**Sandia Corporation
Albuquerque, New Mexico
December 15, 2006**

**DOE/Sandia Responses to NMED's
“Notice of Disapproval: Mixed Waste Landfill Corrective
Measures Implementation
Work Plan, November 2005”**

Comment Set 1

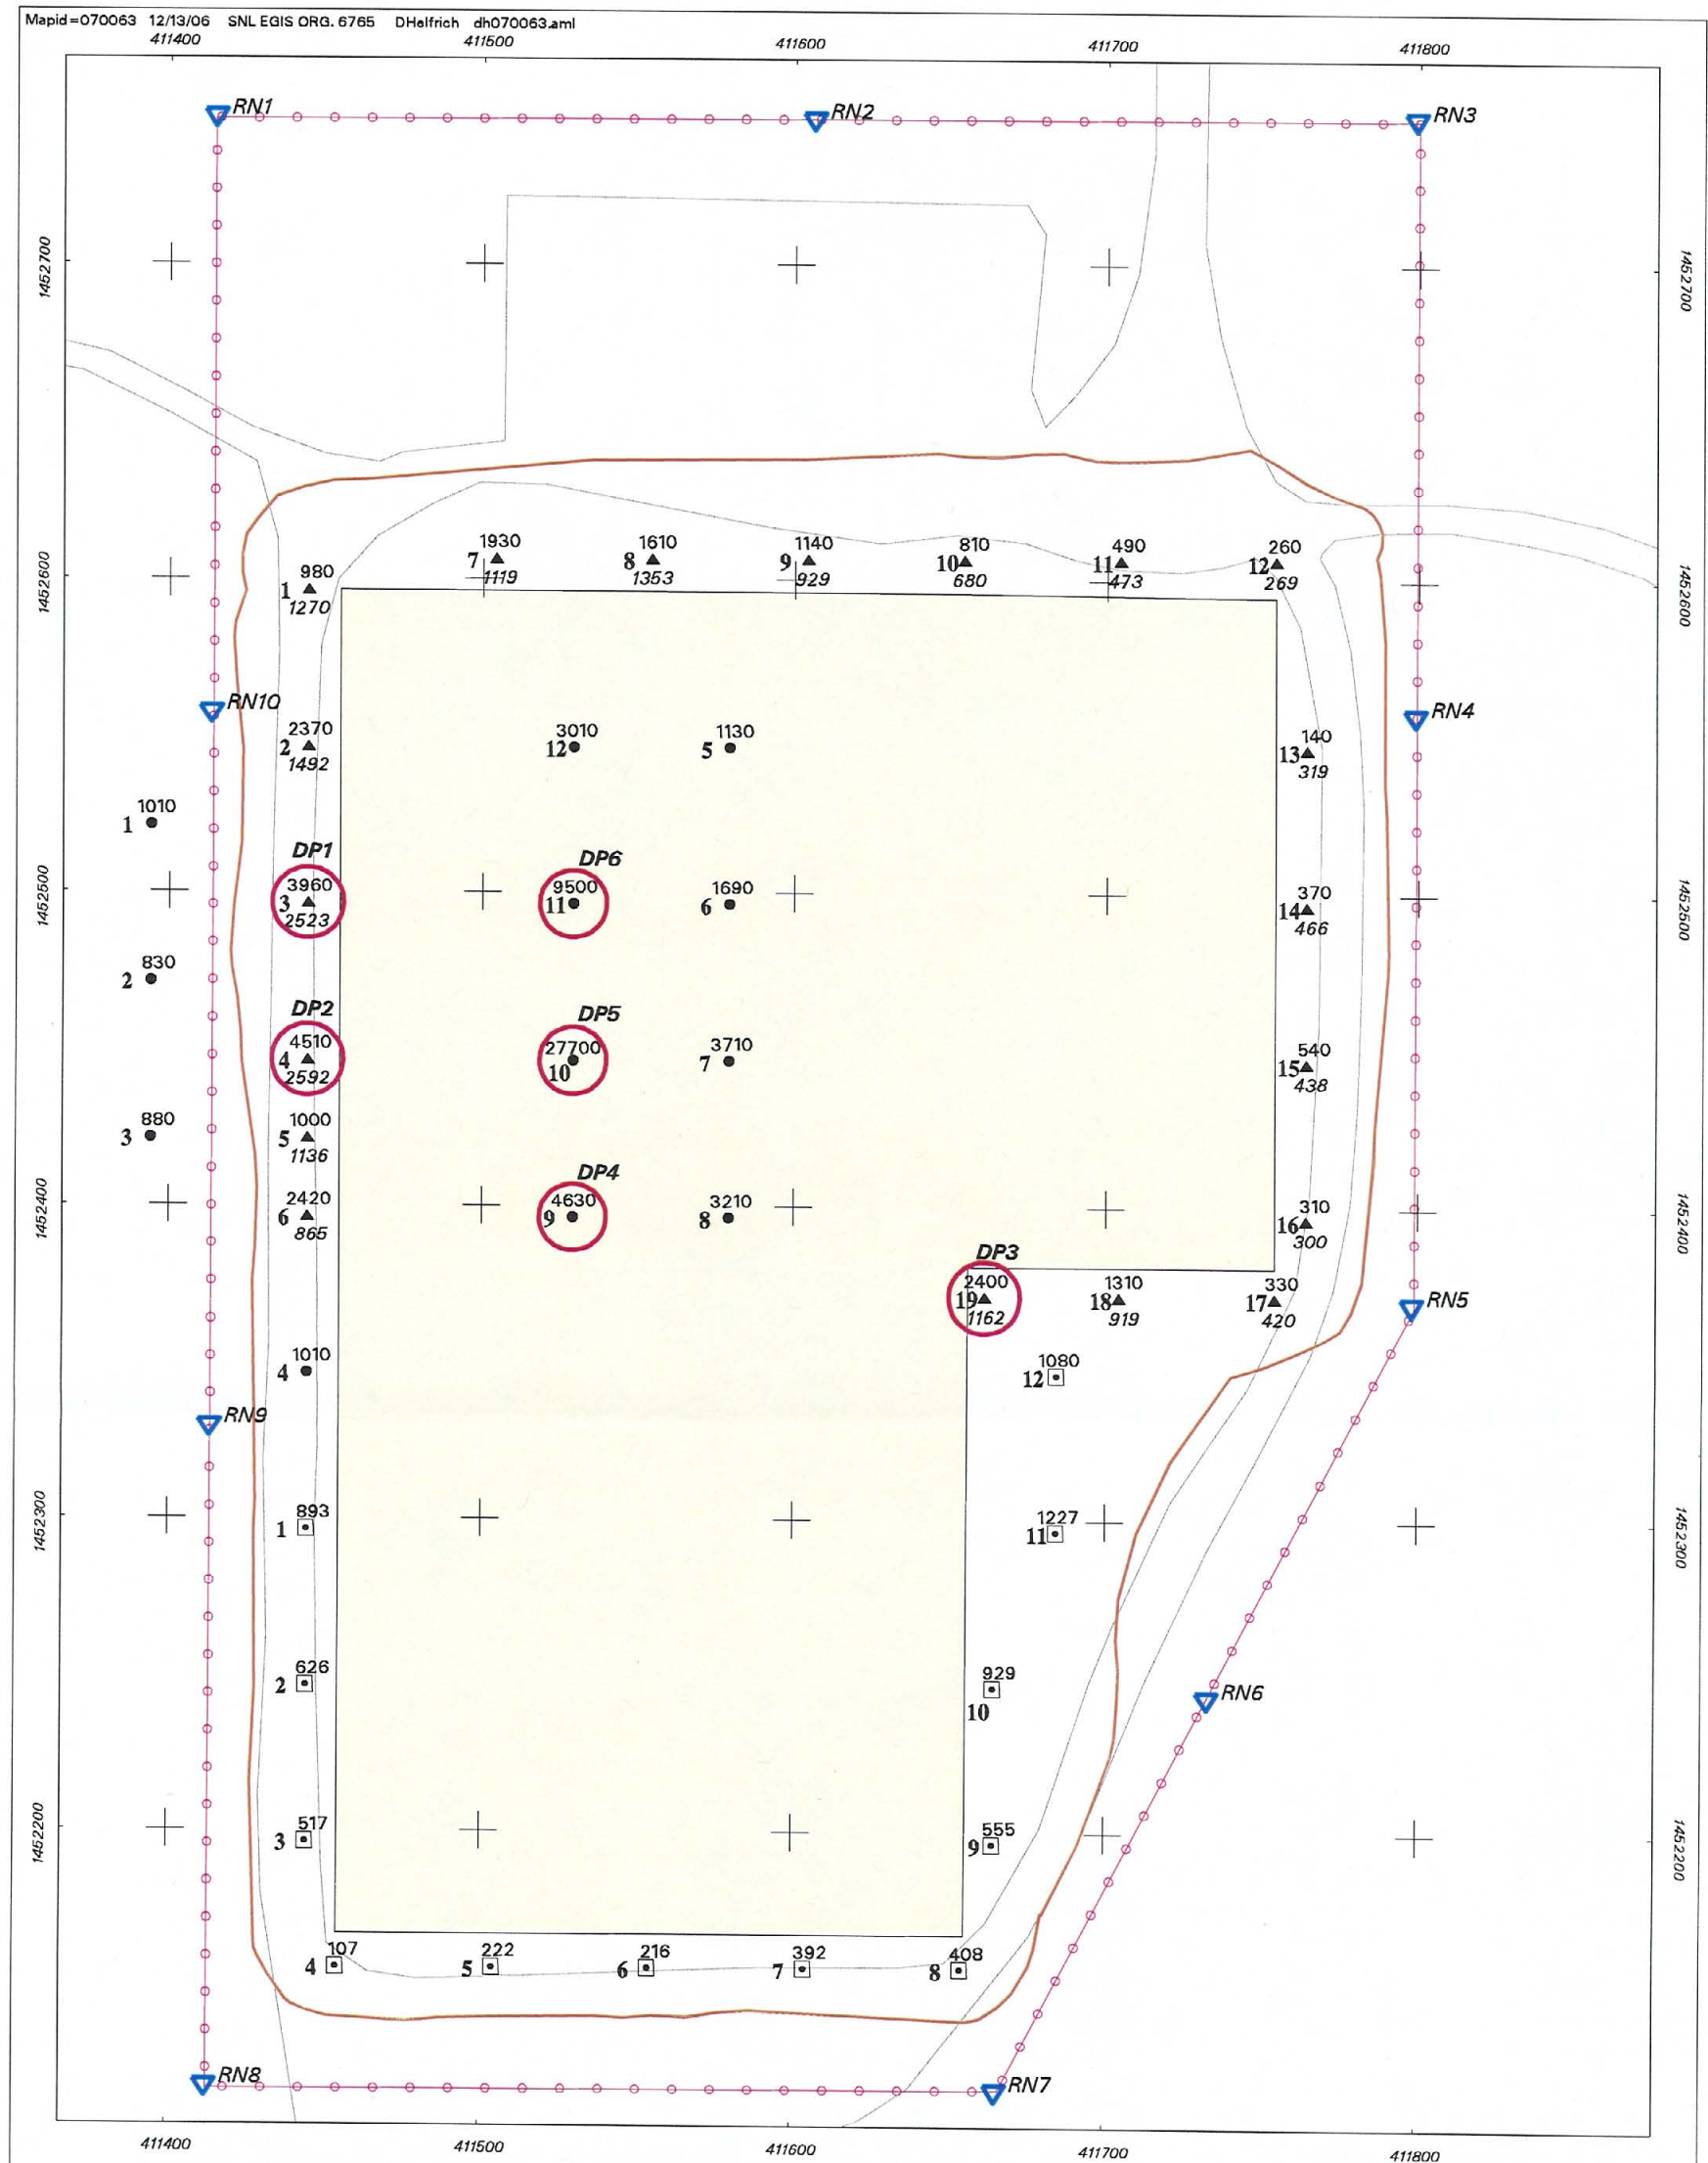
The Mixed Waste Landfill Corrective Measures Implementation Work Plan was written and submitted to the NMED Hazardous Waste Bureau in November 2005 (SNL/NM November 2005). NMED reviewed the document, and responded with a “Notice of Disapproval” letter dated November 20, 2006 (NMED November 2006). This letter described a number of deficiencies related to both the MWL cover, construction plans, performance and fate and transport modeling, and monitoring triggers. The letter also included a requirement for additional soil gas sampling at the landfill, as follows:

Analytical results for the 1994 soil gas samples are presented and discussed in the “Report of the Mixed Waste Landfill Phase 2 RCRA Facility Investigation, Sandia National Laboratories, New Mexico” (SNL/NM September 1996). Eight individual VOCs were detected in the 10 and 30-ft samples, with total VOC concentrations ranging from 0.03 to 30.7 parts per million (ppm) in the 10-ft bgs samples, and from 0.107 to 27.7 ppm in the 30-ft bgs samples (Figure 2-1).

As shown on Figure 2-1, radon levels around the perimeter of the MWL will be measured using Track Etch radon detectors. A total of 10 detectors will be placed at corners and midpoints of the future perimeter fence that will be constructed once the final MWL cover has been constructed. For comparison purposes, two additional detectors will also be placed in the area at which the soil gas VOC and tritium background samples will be collected. These detectors will remain in place for one quarter (three months), and at the end of that period will be returned to the manufacturer for analysis.
